# SERVICE BULLETIN

Classification: RA14-001	Reference: NTB14-071	Date: July 29, 2014
-----------------------------	-------------------------	------------------------

## 2014 TITAN; TORQUE SPECIFICATION CHANGE FOR REAR LEAF SPRING BOLTS

**APPLIED VEHICLE** 2014 Titan (A60)  
**APPLIED VIN AND DATE:** Built **after** 1N6BA0EC(\*)EN 517870 and July15, 2014

Figure 3

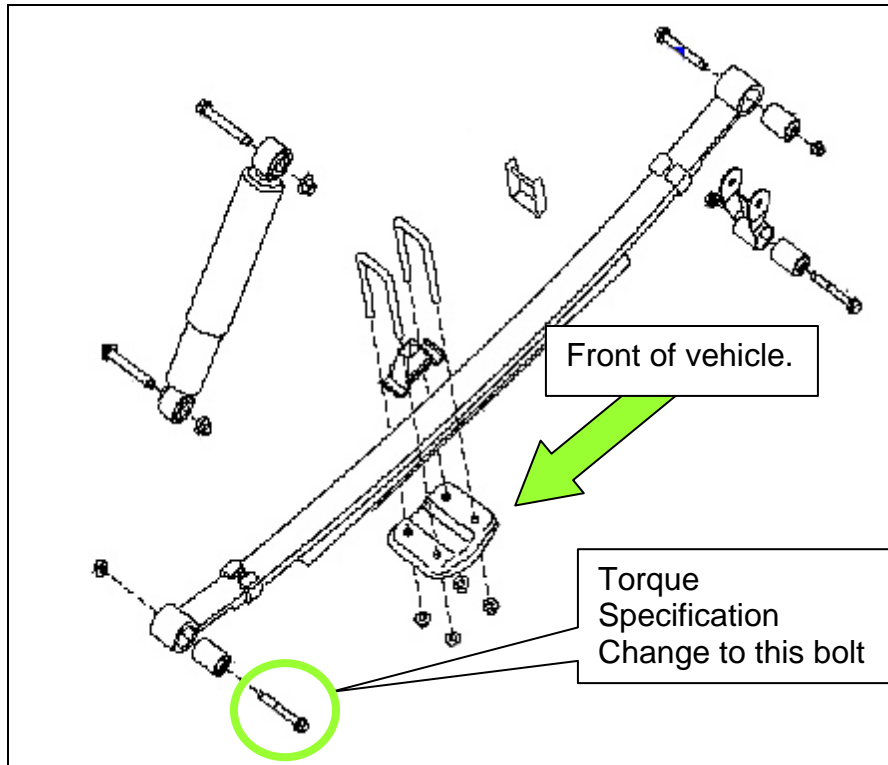
The rear leaf spring front attachment bolt (see Figure 3) has been changed to use a low friction coating. The service specification for torque of the new bolt (Figure 2) has been changed from 223 N•m (**164 Ft-lbs**) to 102.5 N•m (**75.6 Ft-lbs**).

If this bolt is removed or replaced as part of a service repair, and it is confirmed that this bolt has the new low friction coating, use only the new torque specification in Figure 2.

**New Bolt:** 55080-9FM0A  
 Silver/grey Appearance  
 Torque Value 102.5 N•m (**75.6 Ft-lbs**)
